SERVICE INFORMATION

Vol. 1 No. 21

LAND-ROVER PETROL AND DIESEL MODELS

November, 1973

Fig. 1. Location of surge protection device

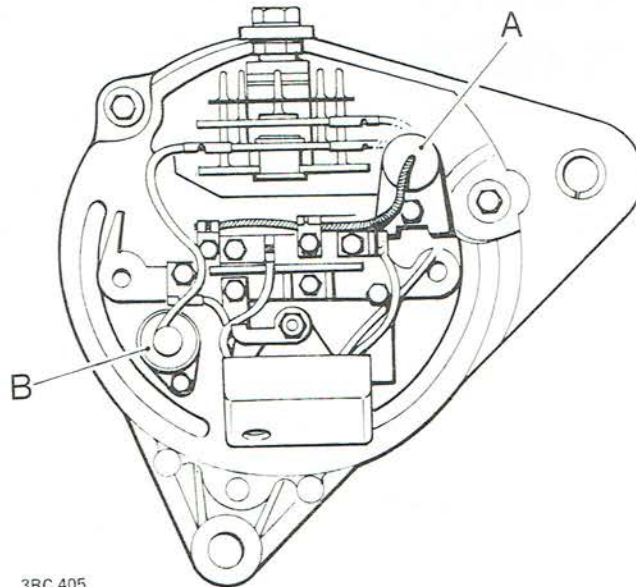
Item 91**SUBJECT: SURGE PROTECTION DEVICE****MODELS:** Land-Rover with 18 ACR alternator.**OBJECTIVE:** To introduce a surge protection device.**PART NUMBER:** Surge protection device 1 608425

REMARKS: A surge protection diode has been incorporated in the current range of Lucas ACR alternators. The diode is connected between the 'IND', terminal and earth, which protects the regulator and/or alternator diodes from high voltage surges due to poor external wiring connections or battery lead removal when the engine is running.

The above surge protection device can be fitted to earlier ACR alternators. However, it may be necessary to re-locate the suppressor to the position shown.
